## **NOTICE TO BIDDERS**

ADDENDUM #1

BID #102-23: Escondido Center Campus Security Enhancements Project

### **Palomar Community College District**

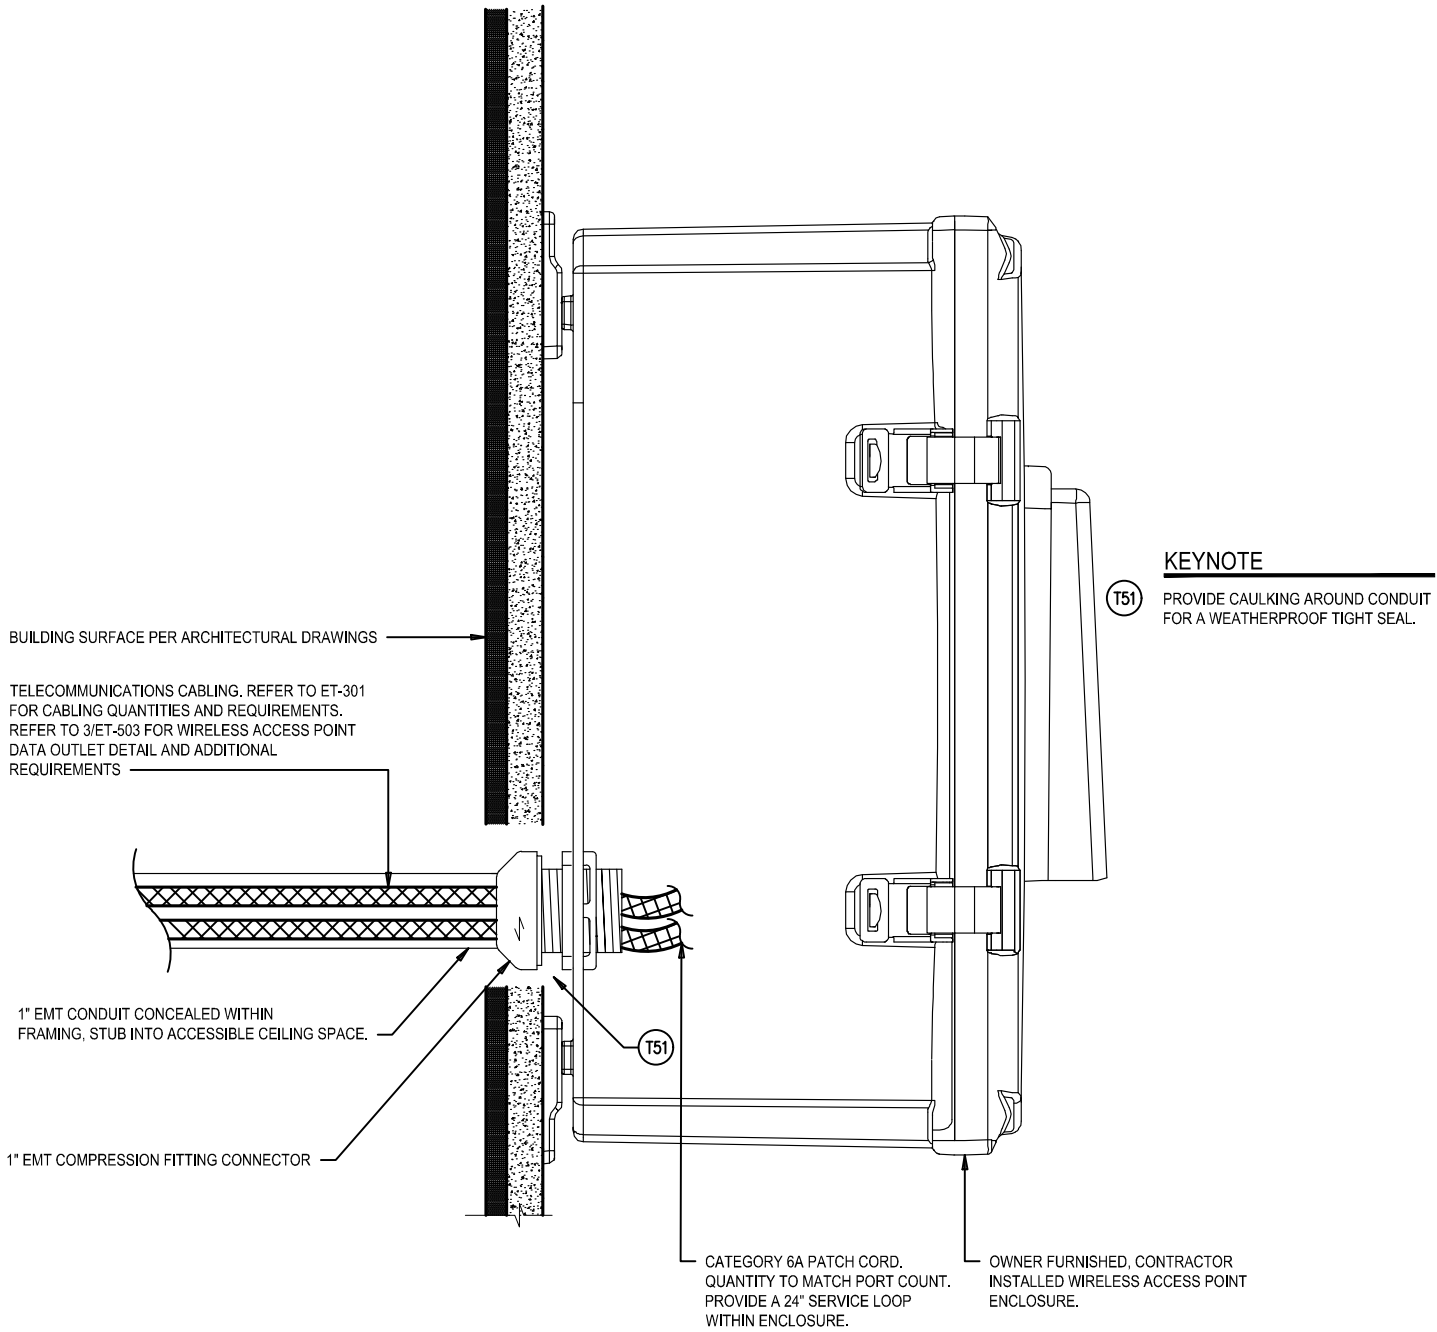
(14) QUESTION: Telecommunications: Please provide J-Hook attachment detail?

*RESPONSE: Drawings updated to include the J-hook attachment detail.*

**TITLE:** EXTERIOR WAP ENCLOSURE DETAIL (BID ADD.01)

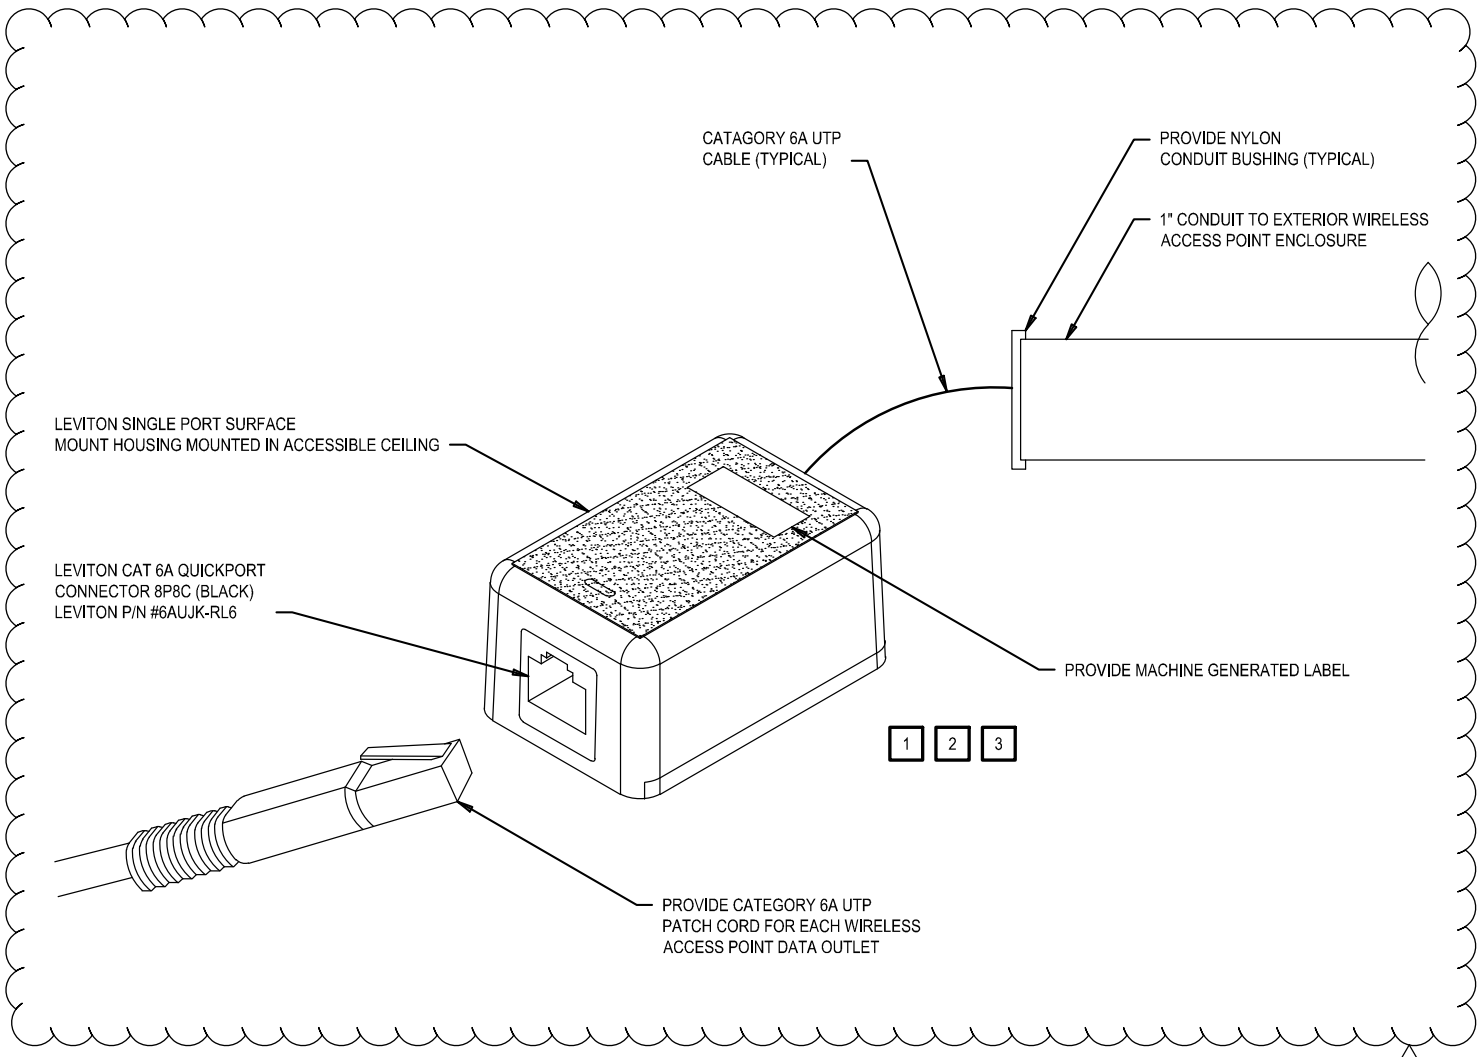
**(T51)** PROVIDE CAULKING AROUND CONDUIT FOR A WEATHERPROOF TIGHT SEAL.
